PUBLIC HEARING

Proposed Conditional Use Permit for Four New Professional and Medical Office Buildings on Property Located in the Neighborhood Business District (B-1) near Riverpark Drive and the Grand Parkway

Ms. Laura Waller, Planner I

Site Plan

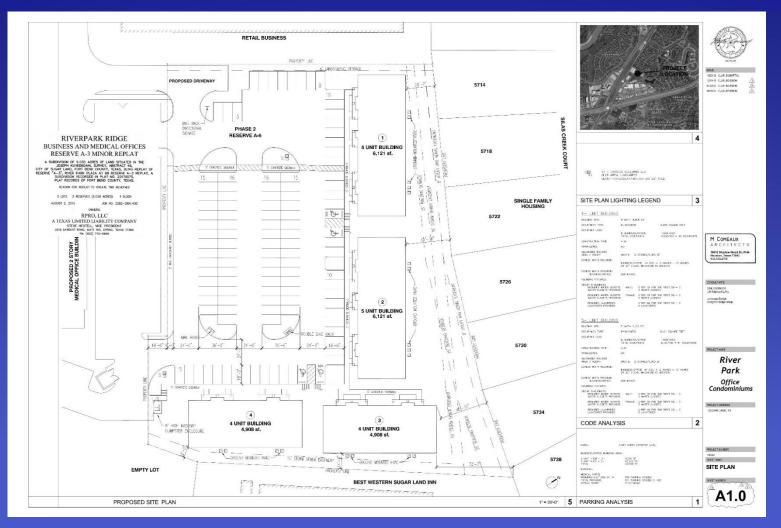
- No doors, lights, sidewalks, or drive aisles in the rear of the buildings along the singe family property line
- Buildings vary from 26' 7" to 45' 10" from property line (all exceeding min. 25' rear setback)
- 6 existing Oak trees to remain, and a solid line of alternating Oak and Elm trees in landscape buffer between development and homes.
- Existing 6 foot wood fence proposed to remain:
 - Staff recommends upgrading this fence to masonry based on past recommendations for similar locations.

Landscape Plan (excerpt)

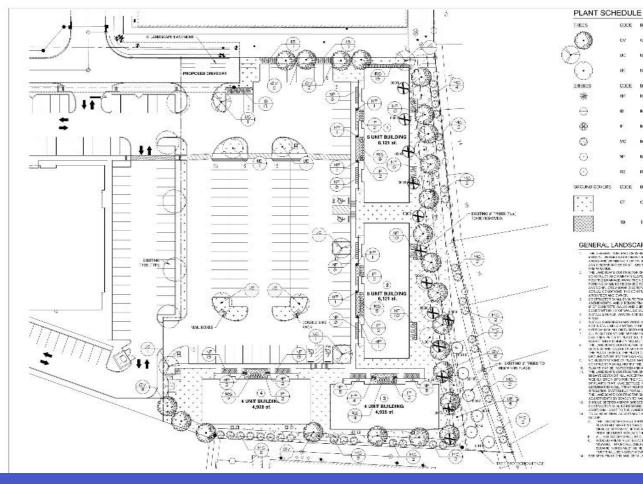
- Neighborhood Business (B-1) with shared property line with Single Family Residential—plans need to be examined closely to reduce impact on homes from commercial areas
- All buildings proposed as one-story Medical Office Buildings (MOBs) and there are no doors, lighting, or drive aisles along the residential lot lines
- Elevations provided show buildings are entirely comprised of masonry and glass.
- 16 to 36-foot-wide landscape buffer along the rear of the property. The Oak trees being planted in this buffer area are to be no less than 4-inch caliper when planted, and 6 trees to be preserved at the northeast corner
- There is an existing 6-foot wood fence along the residential lot lines. Staff believes that the existing fence does not provide adequate long-term screening, and that the applicant should upgrade to masonry as required by City Council in similar residential proximity CUPs.

- Site Plan
- 4 & 5 Unit Building Elevations
- Landscape Plan
- Photometric Plan
- Suggested Conditions of:
 - Applicant will work with residential property owners to the rear in regards to the fence and how it will be maintained.
 - The fence will be constructed of cast concrete or masonry material with architectural detail on both sides
 - Prohibit outdoor speakers
